AMC Engineering PLLC

February 14, 2025

Re: *Response to Comments - Revised 2023-2024 Periodic Review Report (PRR)*
Site: *11-28 31st Drive*
Site No.: *C241159*
Location: *11-28 31st Drive, Queens, NY 11106*

| | Figure 2 |

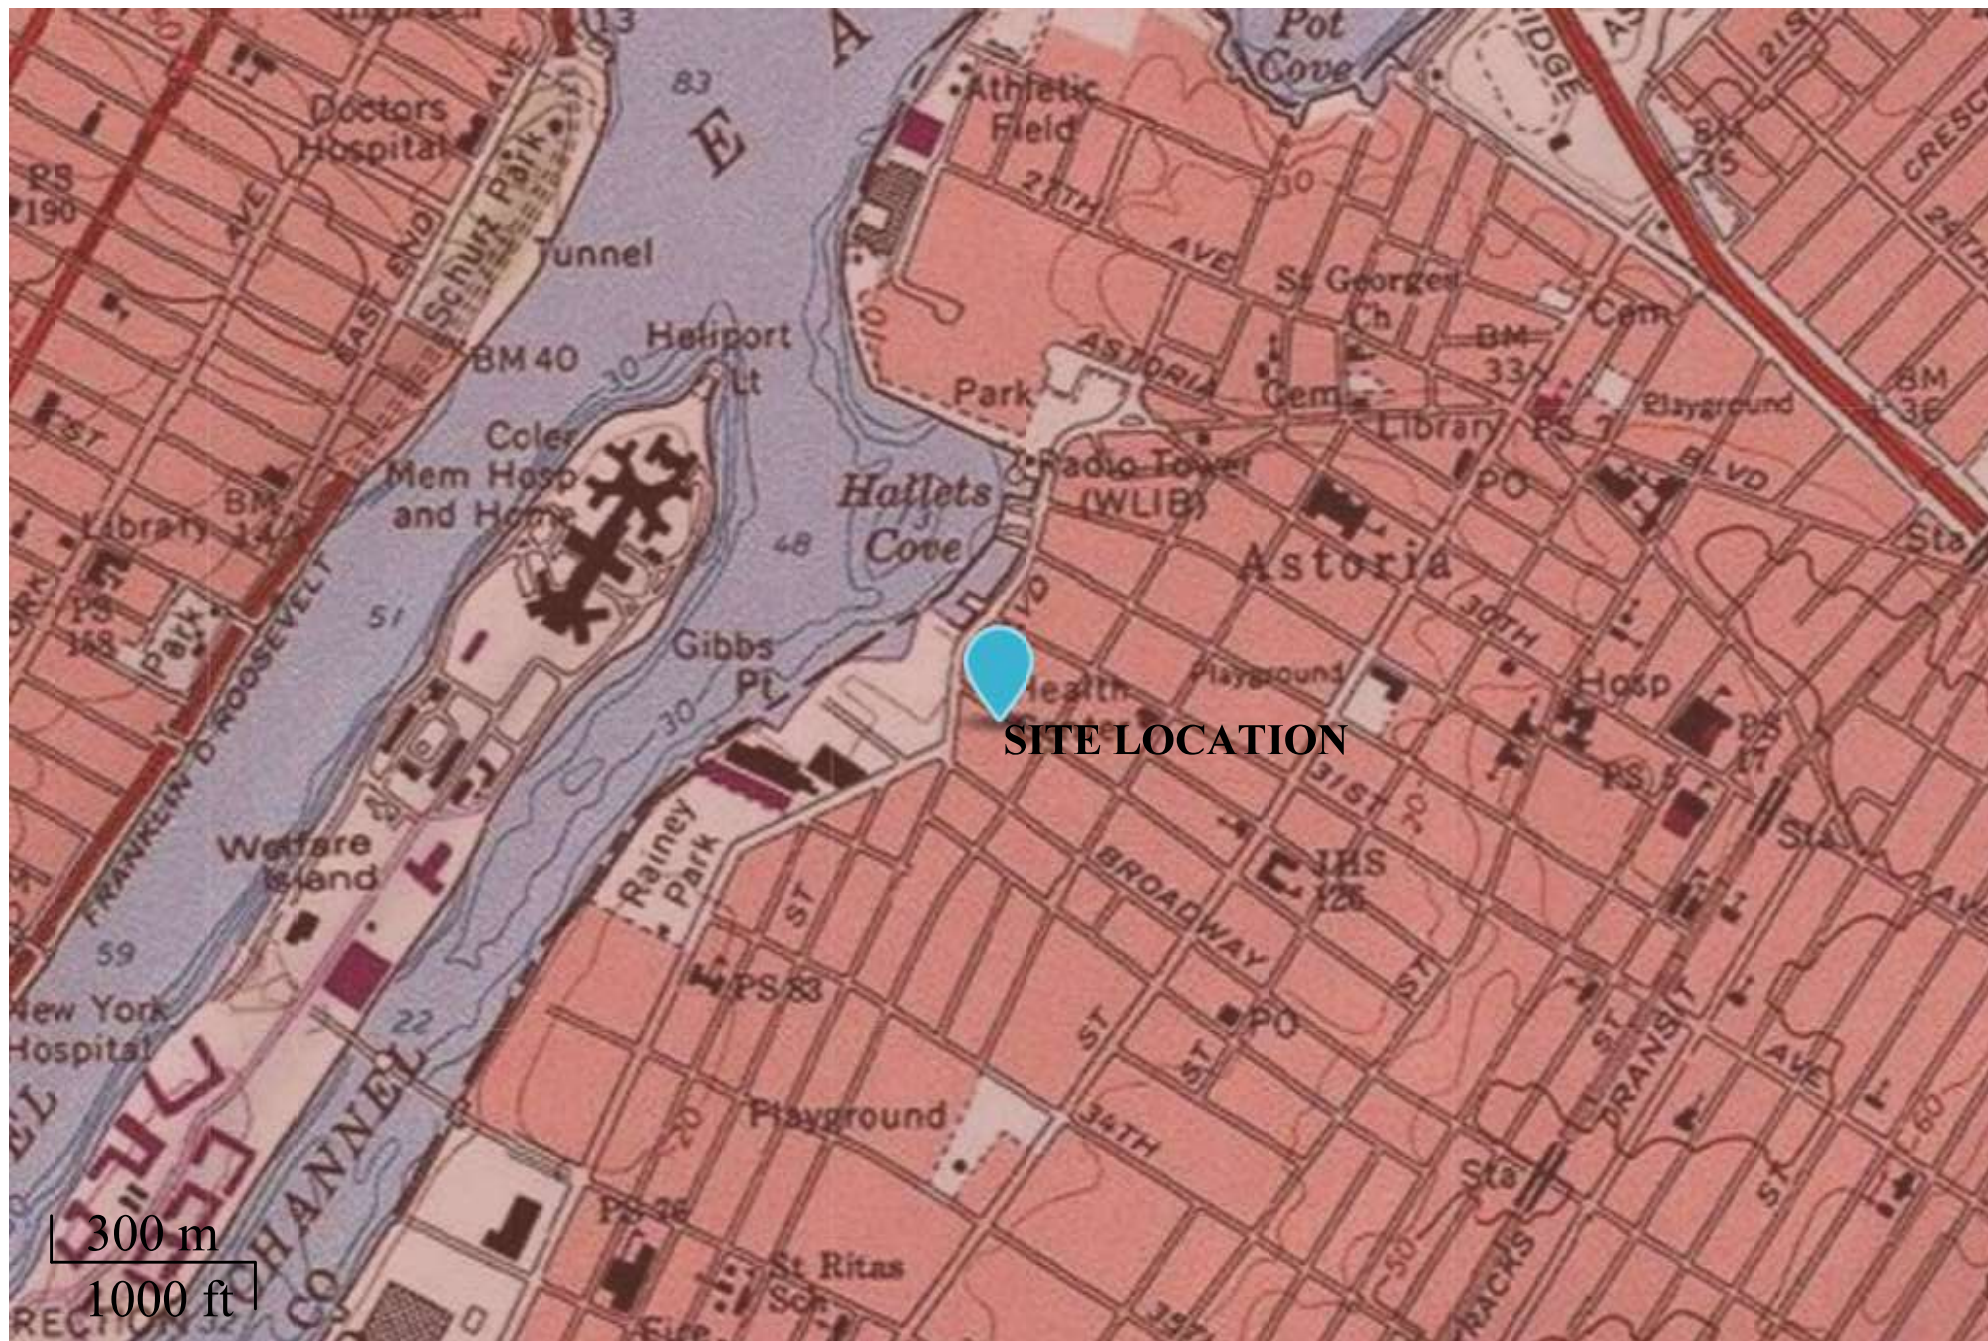
Modification 6, Figure 2 (Site Layout Map): The figure portraying the SSDS does not currently show the SSDS design or the area of influence/radius of capture of the SSDS. Please include the SSDS as-built figure (from the SMP) and display the area of influence/radius of capture of the SSDS.

-SSDS As-Built Figure from SMP has been included with the area of influence in Figure 4.
